SUBJECT: CATAWBA NUCLEAR STATION, UNITS 1 AND 2 – ISSUANCE OF
AMENDMENT NOS. 306 AND 302 TO REVISE TECHNICAL SPECIFICATION
3.4.3, "REACTOR COOLANT SYSTEM PRESSURE AND TEMPERATURE
LIMITS" (EPID NO. L-2019-LLA-0141)

The amendments revise Technical Specification (TS) 3.4.3, "RCS [Reactor Coolant System] Pressure and Temperature (P/T) Limits," to reflect an update to the P/T limit curves in Figures 3.4.3-1 RCS Heatup Limitations (UNIT 1 ONLY) and 3.4.3-2 RCS Cooldown Limitations (UNIT 1 ONLY) for Catawba, Unit 1. The proposed change will also reflect that the revised Catawba, Unit 1 P/T limit curves in TS 3.4.3 are applicable until 42.7 effective full power years (EFPY). Although the TSs are common to both Catawba, Unit 1 and Unit 2, the proposed changes are only applicable to Catawba, Unit 1. The applicable TS 3.4.3-1 RCS Heatup Limitations (UNIT 2 ONLY) and TS 3.4.3-2 RCS Cooldown Limitations (UNIT 2 ONLY) for Unit 2 remain unchanged.

SAFETY EVALUATION BY THE OFFICE OF NUCLEAR REACTOR REGULATION

Figure 3.4.3-1
(UNIT 1 ONLY)
RCS Heatup Limitations (Without Margins for
Instrument Errors)

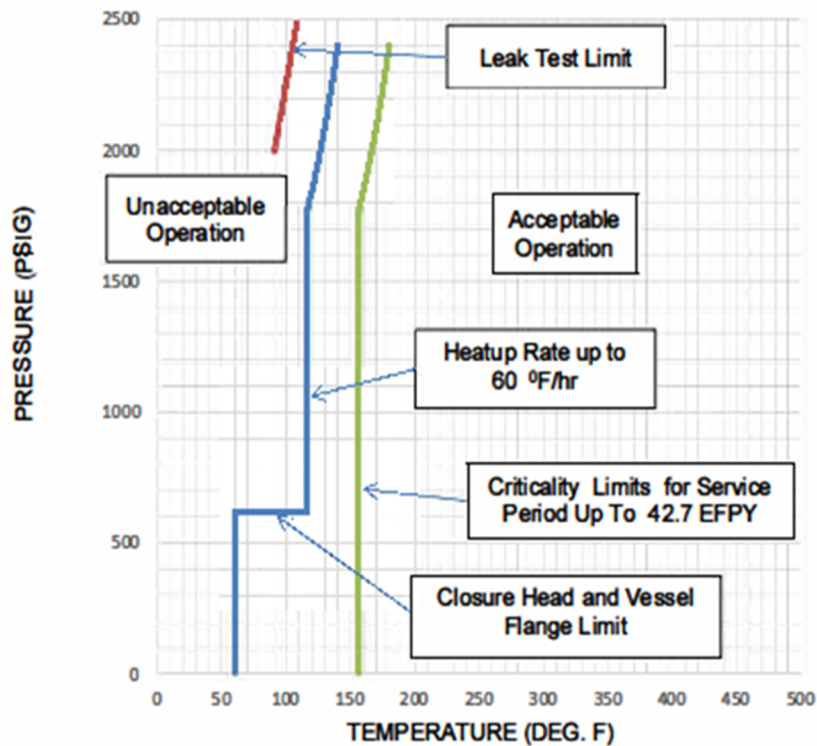
TS 3.4.3, Figure 3.4.3-1, "(UNIT 1 ONLY) RCS Heatup Limitations," proposed change is as follows:

- The existing RCS heatup limitations curve is superseded entirely by a new curve applicable up to 42.7 EFPY.

- The words “Upper Shell Forging 06, Intermediate Shell Forging 05, and Bottom Head Ring 03” for the “Limiting Material” are revised to state “Lower Shell Forging 04, Intermediate Shell Forging 05”.
- The words “Limiting ART [adjusted reference temperature] at 30.7 EFPY” are revised to state “Limiting ART at 42.7 EFPY”.
- The “1/4-T” value of “42 °F” is revised to state “47 °F”.
- The “3/4-T” value of “31 °F” is revised to state “34 °F”.

The NRC staff determined that there were two potential gaps in relation to the P/T limit heatup curve for 51 EFPY in Attachment 1 of the LAR and information related to this P/T curve that WEC had included in WCAP-15448, Revision 1 (i.e., Attachment 2 of the LAR): (a) WEC did not include the 10 CFR Part 50, Appendix G, minimum temperature requirement in the P/T limit curve in WCAP 15448, Revision 1, for portions of the curve that cover pressures in excess of 20 percent of the RPV preservice hydrostatic test pressure (i.e., $P > 621.25$ psi for Catawba Unit 1),¹ and (b) the staff's independent calculation of its P/T limit heatup curve yielded slightly more conservative P/T limit points than those calculated by WEC for temperatures lower than 110 °F. However, the NRC staff noted that the DEC's LAR appropriately addressed and resolved these two potential gaps through DEC's inclusion of the appropriate lowest service temperature and minimum temperature requirements in the P/T limit heatup curve that was provided in Figure 3.4.3-1 of LAR Attachment 1.

Although the NRC staff is not endorsing or approving any of the P/T limit heatup curves that were provided by WEC in WCAP-15448, Revision 1, the NRC staff confirmed that DEC's plant-specific heatup curve in the LAR appropriately includes a lowest service temperature/minimum temperature requirement of 60 °F for RCS operating pressures less than or equal to 621.25 psi, and a minimum temperature requirement of 116 °F for RCS operating pressures greater than 621.25 psi. Because the NRC staff confirmed that the P/T limit heatup curve provided in LAR Attachment 1 includes the appropriate minimum temperature requirements required by Table 1 in 10 CFR Part 50, Appendix G, the staff concludes that the P/T limit heatup curve in Figure 3.4.3-1 of LAR Attachment 1 is acceptable for implementation by the licensee.

Figure 3.4.3-2
(UNIT 1 ONLY)
RCS Cooldown Limitations (Without Margins
for Instrument Errors)

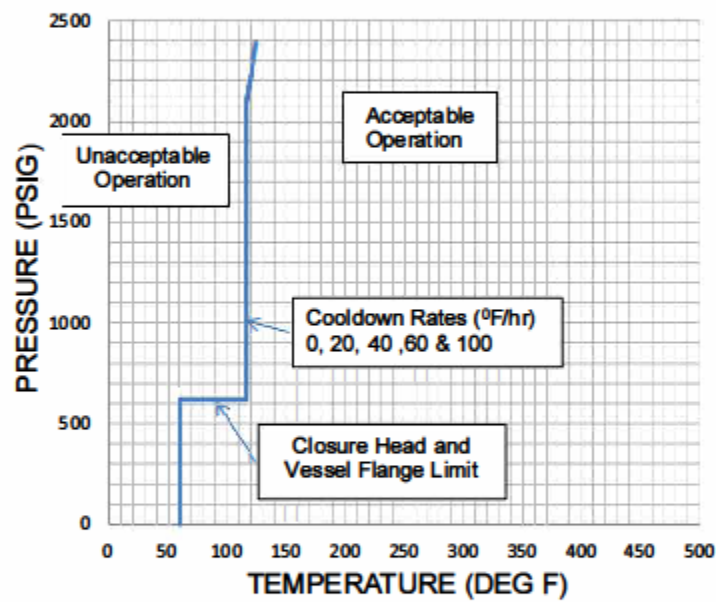
TS 3.4.3, Figure 3.4.3-2, “(UNIT 1 ONLY) RCS Cooldown Limitations,” proposed change is as follows:

- The existing RCS cooldown limitations curve is superseded entirely by a new curve applicable up to 42.7 EFPY.
- The words “Upper Shell Forging 06, Intermediate Shell Forging 05, and Bottom Head Ring 03” for the “Limiting Material” are revised to state “Lower Shell Forging 04, Intermediate Shell Forging 05”.
- The words “Limiting ART at 30.7 EFPY” are revised to state “Limiting ART at 42.7 EFPY”.
- The “1/4-T” value of “42 °F” is revised to state “47 °F”.
- The “3/4-T” value of “31 °F” is revised to state “34 °F”.

The NRC staff confirmed that the licensee's proposed P/T limit curves provided in Figure 3.4.3-1 of LAR Attachment 1 for pressure test conditions and for operational changes with the reactor in the critical condition and in Figure 3.4.3-2 of LAR Attachment 1 for reactor cooldown conditions were conservative relative to those calculated by the staff in accordance with ASME Section XI, Appendix G. The NRC staff also confirmed that the P/T limit curves included the appropriate minimum temperature/lowest service temperature requirements in Table 1 of Appendix G of 10 CFR Part 50. Additionally, for the P/T limit curve that applies to plant operations when the reactor is critical, the NRC staff noted that the licensee's curve conservatively sets a minimum temperature requirement (T_{min}) of 156 °F (i.e., $T_{min} = \text{limiting } RT_{NDT-\text{Closure Flange}} \text{ of } -4 \text{ °F} + 160 \text{ °F}$)
